SUBJECT: NRC NDE INDEPENDENT MEASUREMENTS INSPECTION AT
COMANCHE PEAK, UNIT 1

Report Nos. 50-445/89-38
50-446/89-38

Facility Name: Comanche Peak Units 1 and 2

Inspection Summary and Conclusions: A routine unannounced inspection was conducted at Comanche Peak Nuclear Power Station on July 17 through July 27, 1989, Report No. 50-445/89-38.

FIG. T-535(a) TYPICAL DISTANCE AMPLITUDE CORRECTION CURVE (ANGLE BEAM METHOD)
(Distance in eighths of a vee-path. For example, 14 is $1\frac{7}{8}$ of a vee-path.)

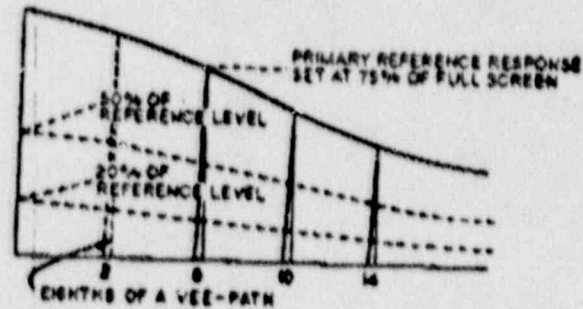
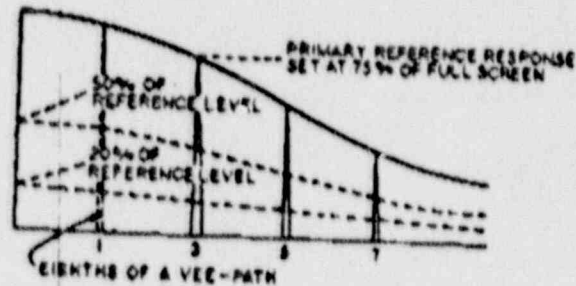
*attached
P.B
to Rev
N01209
page 8.8
the 2/8 does
meet the 3/8
Vee-path!*

FIG. T-535(c) TYPICAL TWO SEARCH UNIT TECHNIQUE FOR DETECTING TRANSVERSE DISCONTINUITIES IN WELDED JOINTS

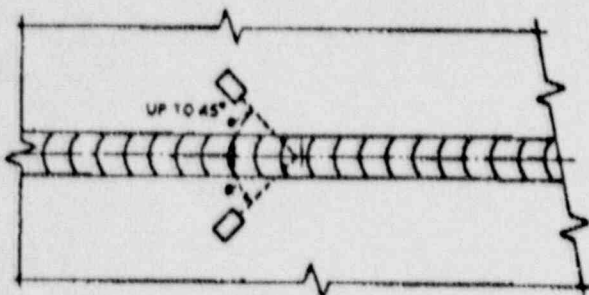
Procedure does not address the

attenuation of
with
+
